Q-375

SVE BULLETIN

2026MY TRANSIT ANTENNA LOCATION

MODEL(S) AFFECTED:
2026MY TRANSIT MEDIUM AND HIGH ROOF VANS

2026MY MEDIUM/HIGH ROOF

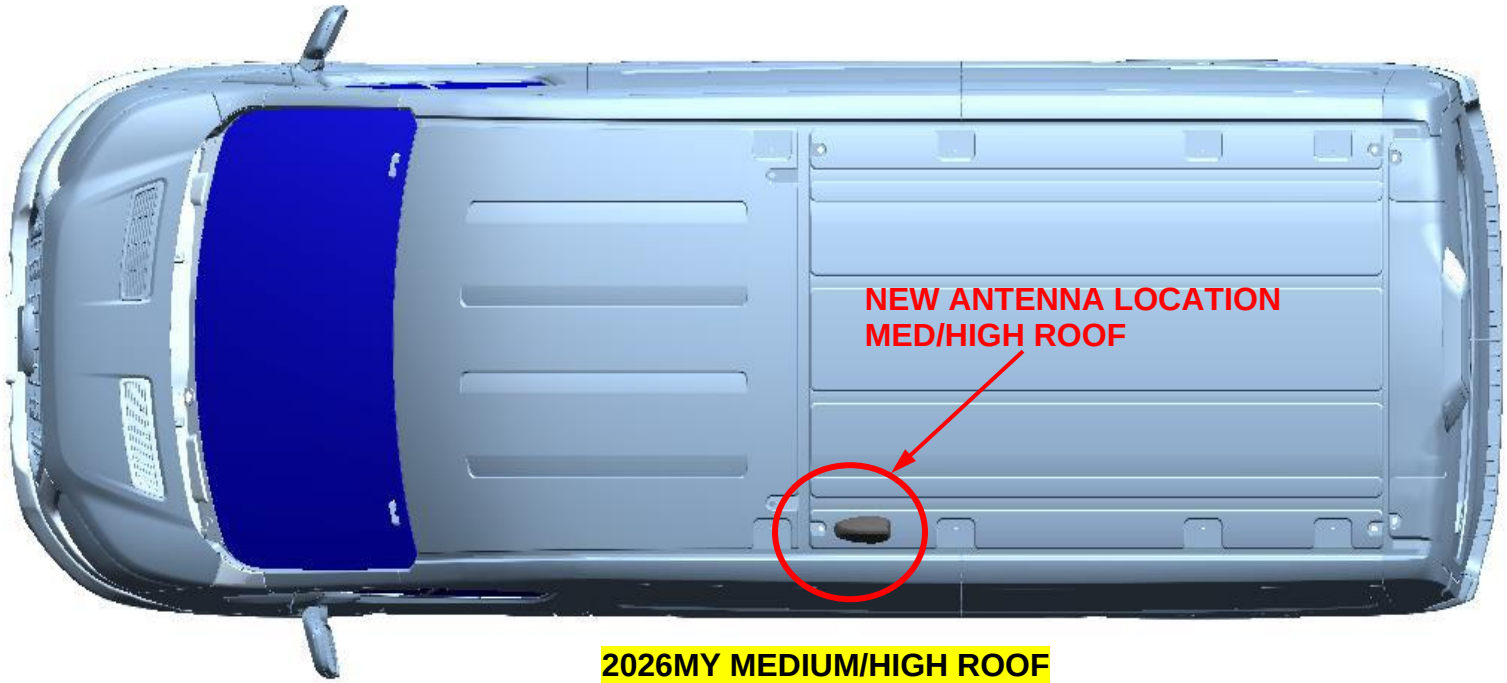
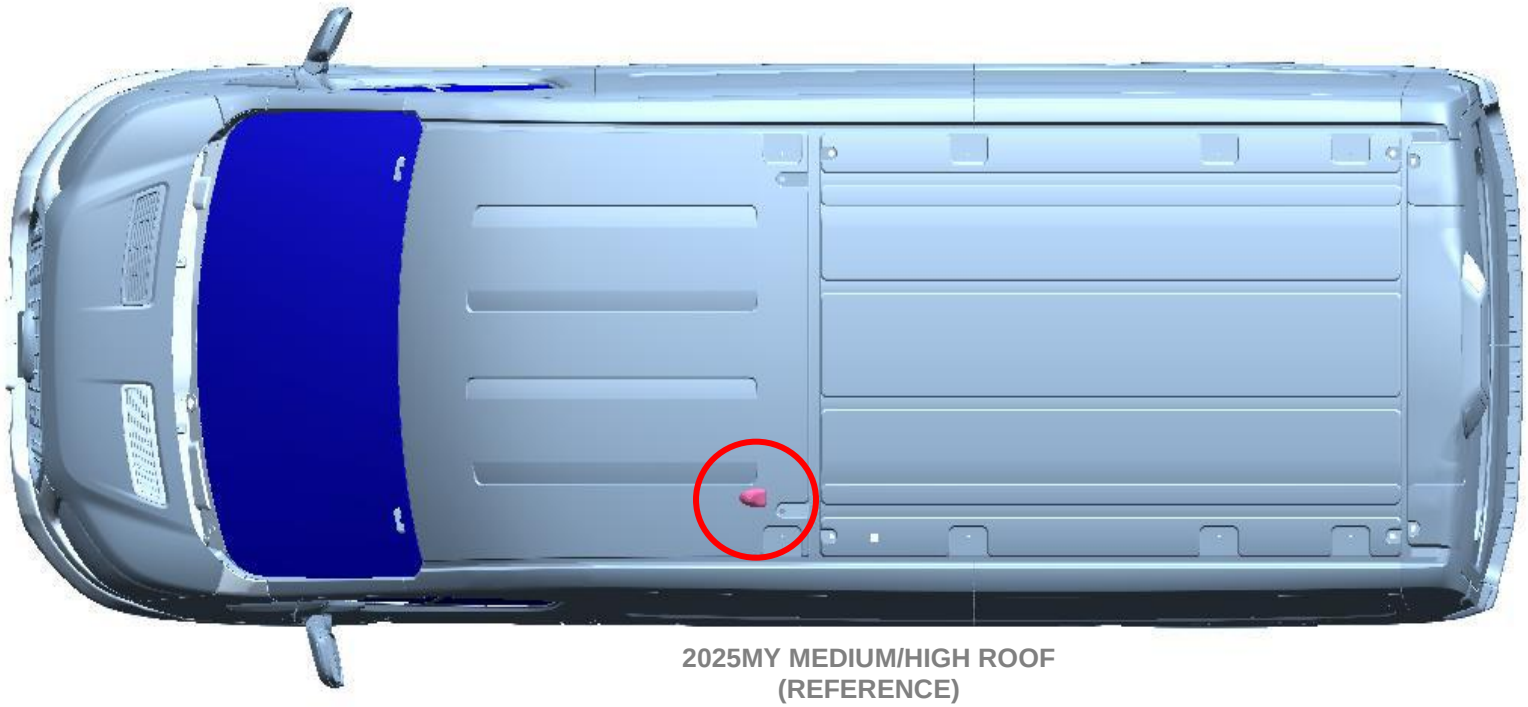
ISSUE / DESCRIPTION:
For the 2026 Model Year (MY) Transit, a new, larger roof-mounted antenna is being introduced.

- **Medium and High Roof Vans:** The new larger antenna will be located farther rearward and more outboard on the vehicle.
- **Cutaway and Chassis Cab:** These models will also use the larger roof-mounted antenna, but its location will remain similar to previous model years.
- **Low Roof:** Instead of a single antenna, Low Roof Transit models will transition to dual low-profile antennas. These will be placed in a similar rearward location as in prior years.

Body Builders are advised to confirm compatibility with any roof-mounted accessories due to these antenna changes. CAD Data is available upon request at https://www.fordpro.com/en-us/upfit/bbas/.
